# Q-317

QVM BULLETIN: Q-317

### 2021MY E-Series Cutaway Vehicles Equipped With Radio Delete And USB Cable

2021MY E-Series Cutaway Vehicles Equipped With Radio Prep-Package

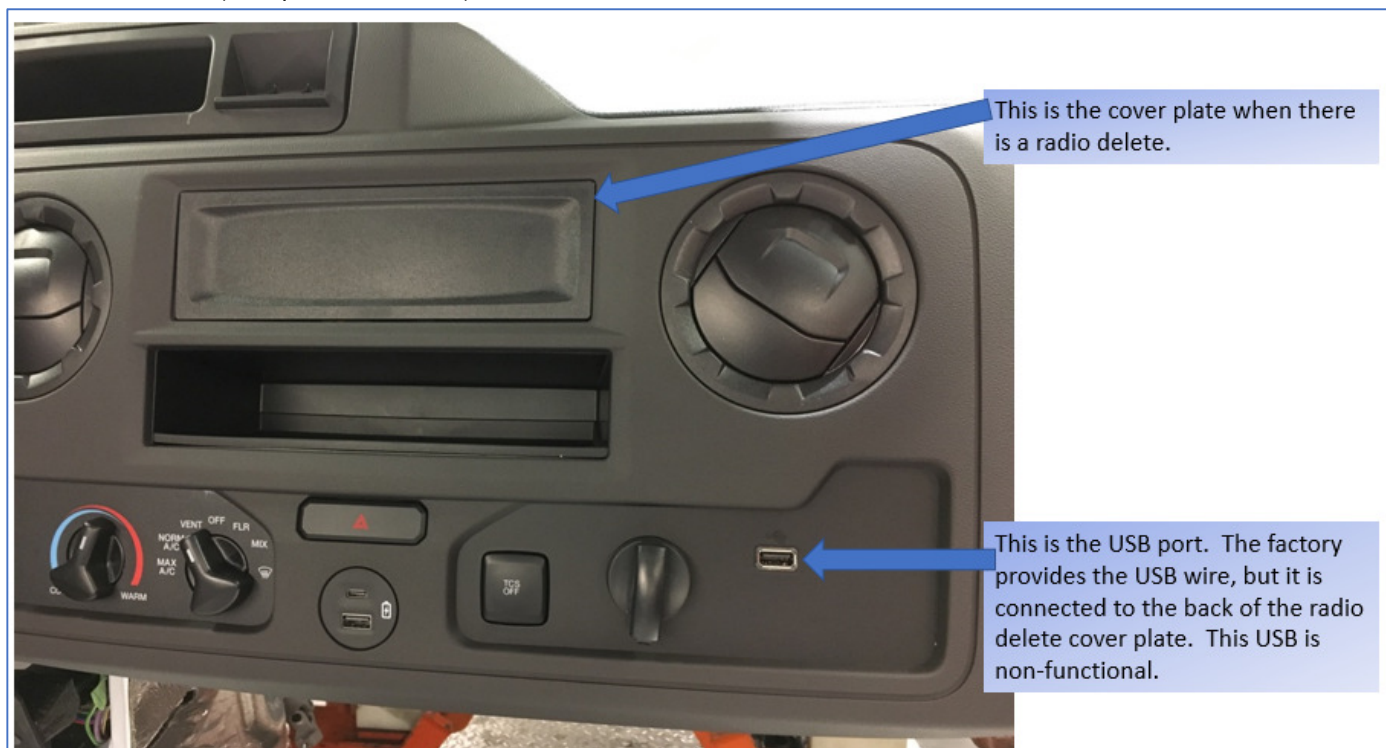
When the vehicle is ordered / equipped with the Radio Prep Package from factory, the USB connector and cable have been installed in the instrument panel. The USB port (shown in image below) will be **non-functional**. It is the Intermediate / Final Stage Manufacturer's responsibility to either remove the USB cable, or construct a cap / cover to hide USB port and USB symbol in the instrument panel, or inform the final customer that the USB port is non-functional.

The Intermediate / Final Stage Manufacturer can make the USB port/wiring functional once again by equipping with an aftermarket radio (or equivalent device) if desired.
